**Proposed EV Mobility City with Ancillary Staff Quarters and
Talent Accommodation at Various Lots in D.D. 51 and
Adjoining Government Land, Fanling
(Application No. Y/FSS/20)**

- Further Information No. 4 -

**S.12A Amendment of Plan Application
Proposed EV Mobility City with Ancillary Staff Quarters
and Talent Accommodation at Various Lots in D.D. 51 and
Adjoining Government Land, Fanling**

(Application No. Y/FSS/20)

Alternative Development Scheme

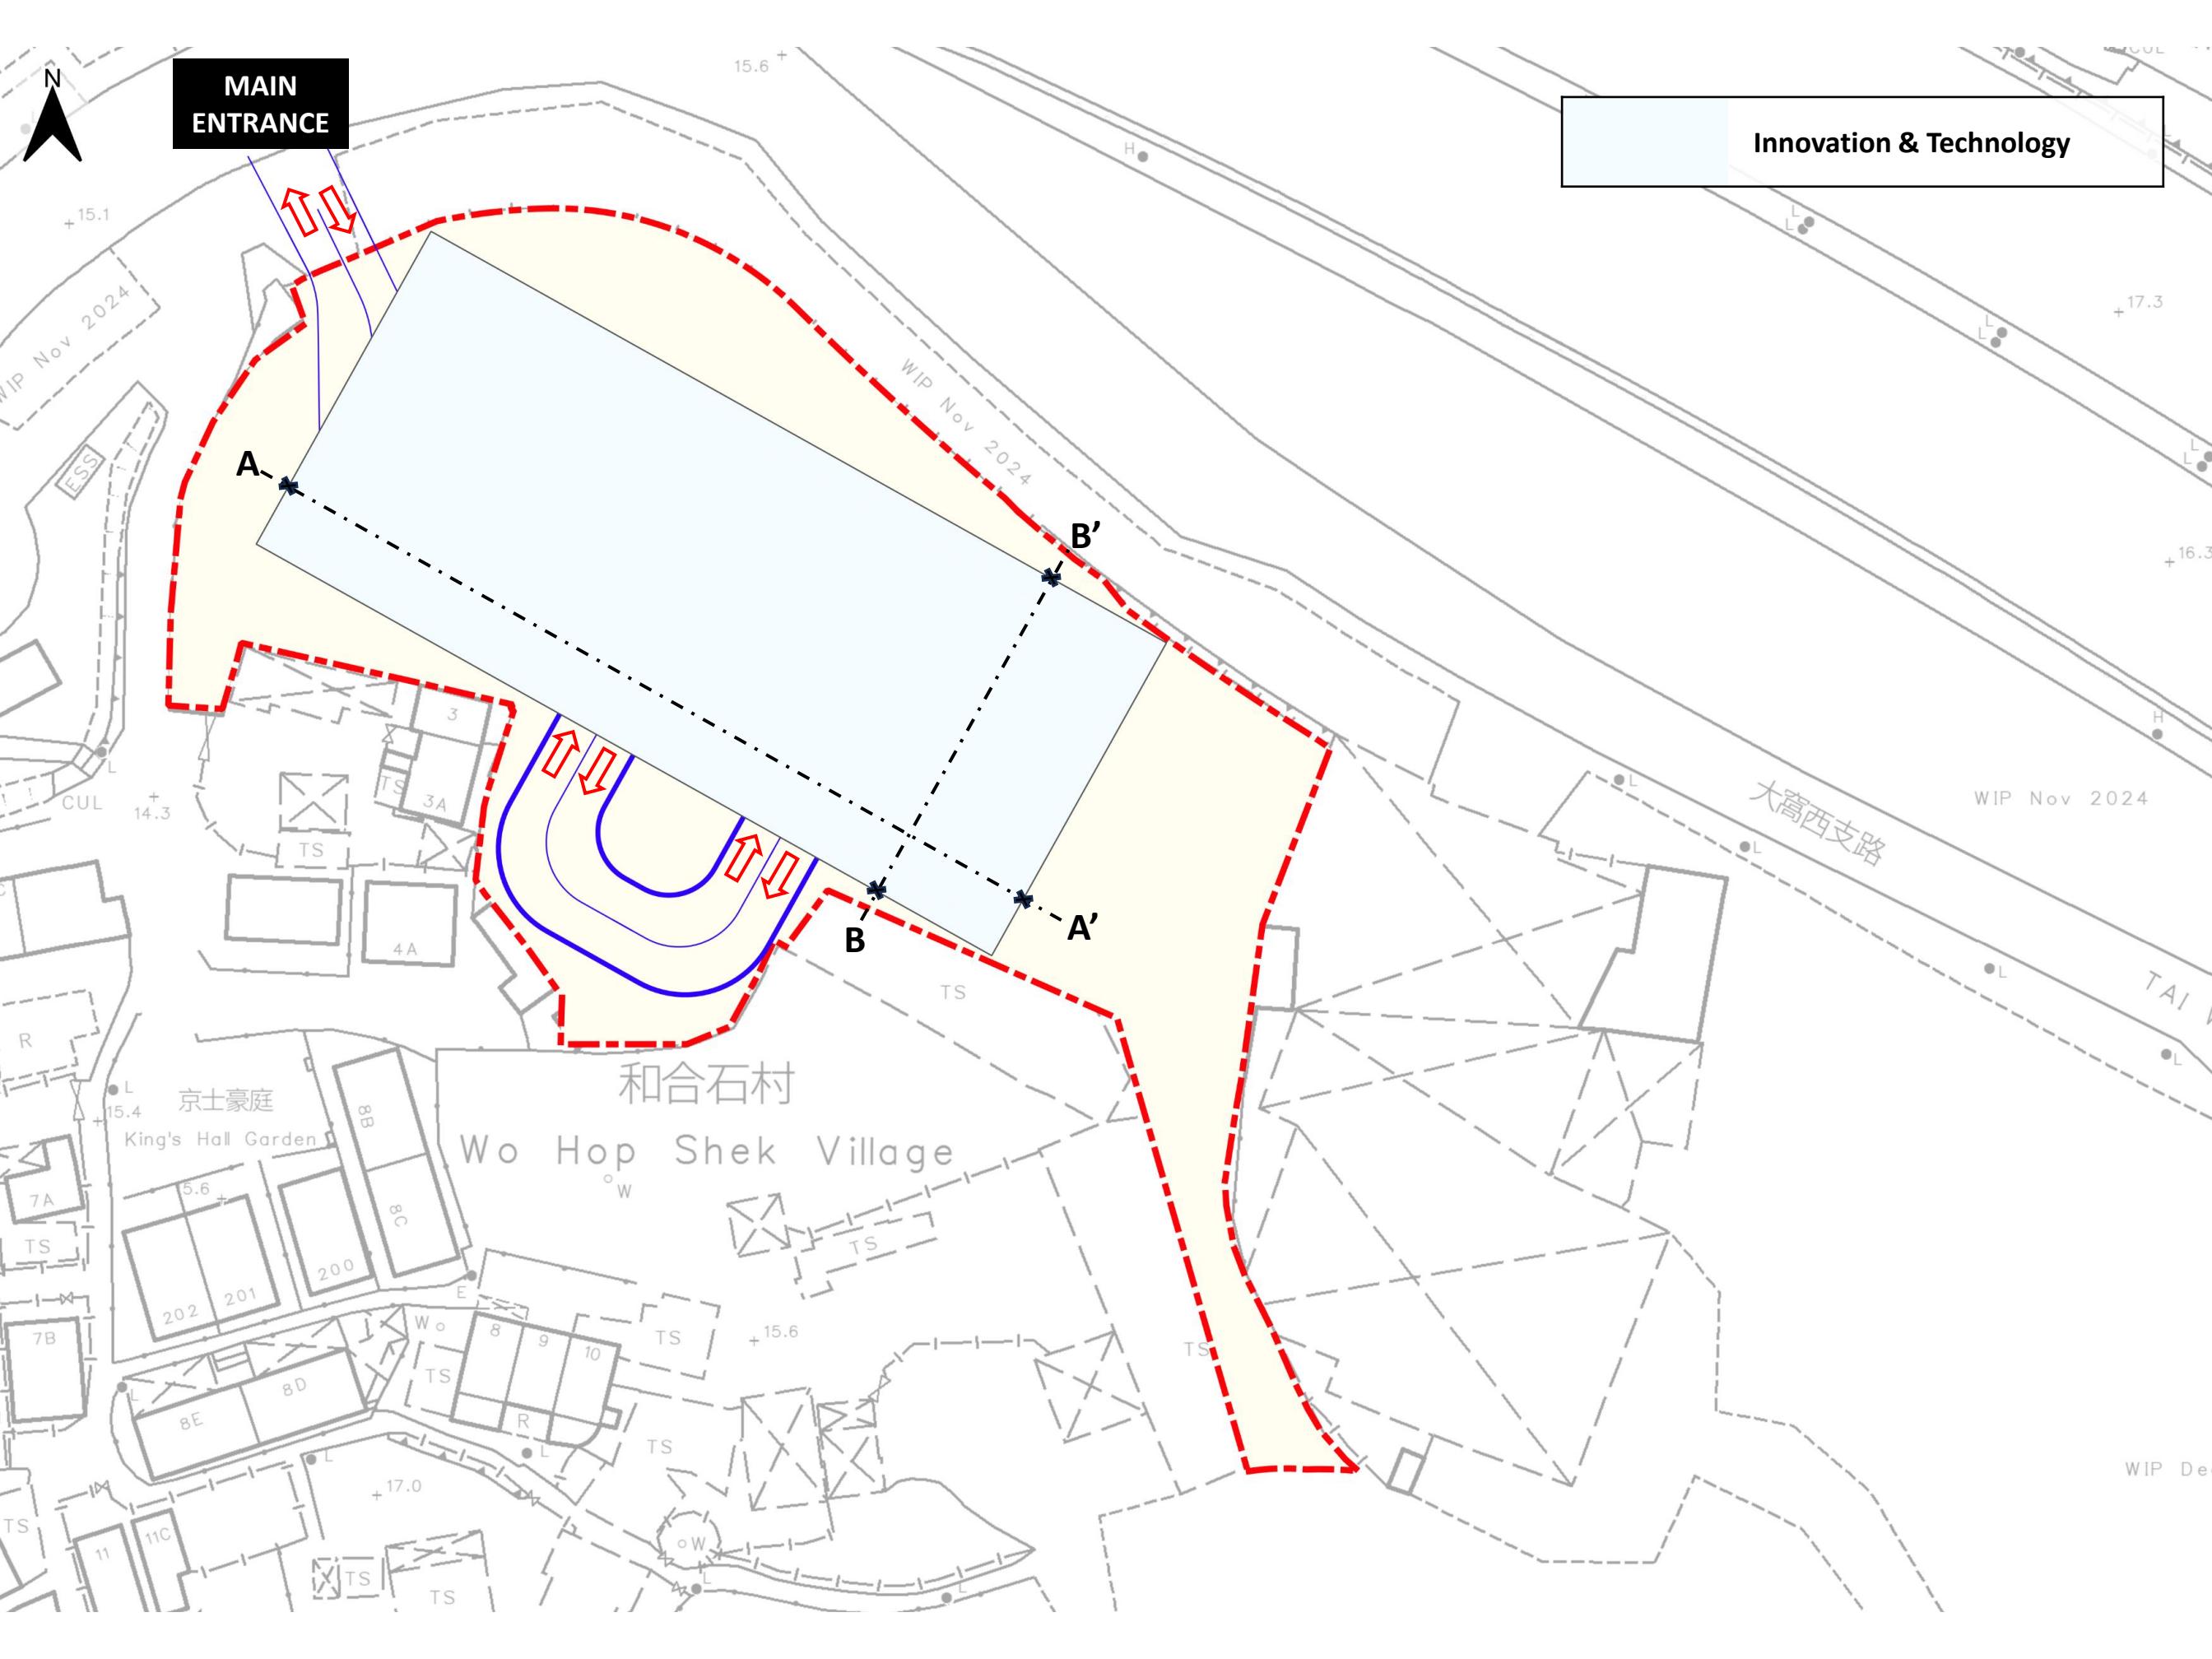
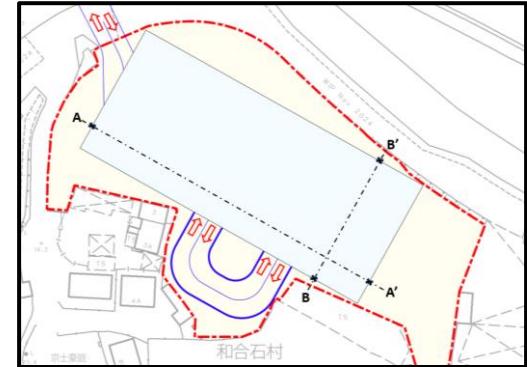
Comments	Responses
Comments from Fanling, Sheung Shui & Yuen Long East District Planning Office, Planning Department (Contact Person: Ms. Andrea YAN; Tel: 3168 4049)	
<p>1. In support of the applicant’s proposal for a non-domestic PR of 5 as stipulated in the proposed Notes for the “OU(I&T)” zone, please provide indicative drawings for a proposed development solely for non-domestic use and illustrate whether such proposal will cause any adverse impact;</p>	<p>An alternative development scheme, illustrating the scenario of a solely non-domestic development, has been prepared at Annex A. As indicated in the respective technical assessments and the elaborations below, from technical perspectives, no adverse impact is anticipated for the scenario of alternative development scheme. Details as follows:</p> <p>Environmental</p> <p><u>Noise</u> Same as the Current Scheme, the Proposed Development, which mainly focuses on clean energy and EV, as well as R&D works, is non-polluting in nature. Noise generating activities, if any, would be located within the enclosed area of the building and positioned away from any noise sensitive receivers (especially the future public housing development at nearby Fanling Area 48) as far as possible. Also, there will be no noisy operations during night-time period (i.e. 23:00 to 07:00). Moreover, the Proposed Development (including work bays and pre-delivery inspection spaces) is not expected to induce any significant noise impact, as the activities involved are only limited to sales, repair/ maintenance, testing and laboratory studies of EVs. In other words, there will be no noise-intensive processes, such as assembly or manufacturing. Regarding the car ramp, appropriate mitigation measures and building design (including but not limited to an enclosed vehicular ramp) will be considered during the next stage of detailed design if found necessary by the relevant Government departments. Therefore, it is anticipated that no adverse fixed noise impact will be generated by the alternative scheme on the surrounding NSRs.</p>

Comments	Responses
	<p><u><i>Air Quality</i></u> Same as the Current Scheme, there is no industrial chimney induced from the alternative scheme and there will not be any industrial activities which involve certain polluting industrial processes classified as “specified processes” under Air Pollution Control Ordinance, Cap. 311. No adverse air quality impact on surrounding air sensitive uses is anticipated during its operation.</p> <p>Drainage & Sewerage</p> <p><u><i>Drainage</i></u> The amount of surface runoff generated from the alternative scheme and flow regime will remain unchanged. Therefore, it is anticipated that there is no adverse impact on the existing drainage pipe receiving runoff from the site.</p> <p><u><i>Sewerage</i></u> The estimated discharge flow rate of the alternative scheme (approx. 287.6 m³/day) will be slightly lower than that of the current scheme (approx. 297.7 m³/day), representing a slight reduction of approx. 10.1 m³ per day. In this regard, the conclusions of the SIA are deemed applicable to the alternative scheme, and thus no adverse impact on the existing sewerage system will be induced.</p> <p>Traffic</p> <p><u><i>j) Difference in Traffic Generation / Attraction</i></u> Traffic generated by the alternative scheme is estimated using the same methodology detailed in the TIA dated 17th December 2025 (hereinafter “the TIA”), and is summarized in Table T1.</p>

Comments	Responses
	<p>which are both negligible compared to the traffic flows in the surrounding road network.</p> <p>The difference in traffic generation / attraction between the Current Scheme and the Alternative Scheme is opined minimal; thus, the analyzed junctions and road links presented in the TIA are expected to continue to operate with similar operation condition comparing with the Current Scheme.</p> <p><i>ii) Provision of Internal Transport Facilities</i> Internal transport facilities provided for the Proposed EV Mobility City will continue to comply with the recommendation under HKPSG. Should the Alternative Scheme be adopted, internal transport facilities will also be provided based on the development parameters and in accordance to the recommendation of the HKPSG.</p> <p><i>iii) Conclusion</i> Both Current Scheme and Alternative Scheme are acceptable from traffic engineering point of view.</p> <p>Visual As compared to the current scheme (a composite development), the alternative scheme features a significantly lower building height at about +72.25mPD. In this regard, it is envisaged that the alternative scheme will bring even a lesser visual impact and that no significant visual impact will be resulted.</p>
